# SERVICE BULLETIN

No. 629

Piper Aircraft Corporation

Subject: Landing Gear Hose Assembly Inspection  
and Replacement.

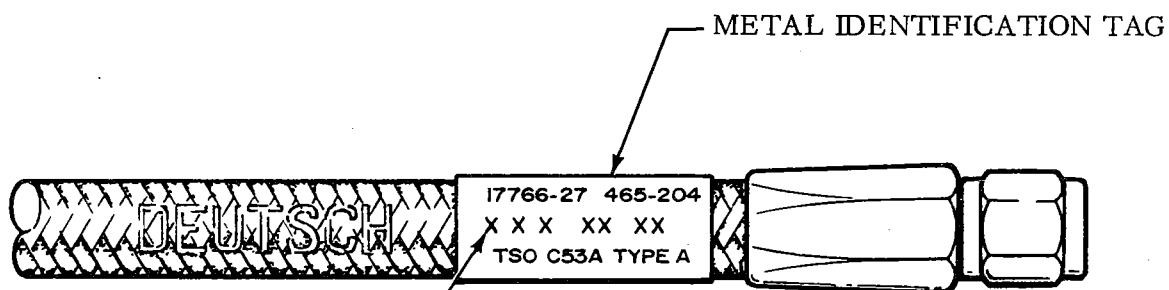
2. Inspect the metal identification tag on the Hose Assemblies for an assembly date of 4Q77 or 1Q78 (See attached sketch).
3. If a Hose Assembly has an assembly date other than 4Q77 or 1Q78, no further action is required. Make an appropriate log book entry of compliance with this Service Bulletin.

INSPECT ASSEMBLY DATE. HOSE ASSEMBLY  
WITH ASSEMBLY DATE OF 4Q77 or 1Q78  
MUST BE REPLACED.

4. If a Hose Assembly is found to have an assembly date of 4Q77 or 1Q78, place the aircraft on jacks (See Service Manual) and proceed with Instructions 5.

5. Remove Hose Assembly(ies) which have assembly dates of 4Q77 or 1Q78. Visually inspect the Hose Assembly for blockage, deterioration or signs of leakage which would indicate delamination.
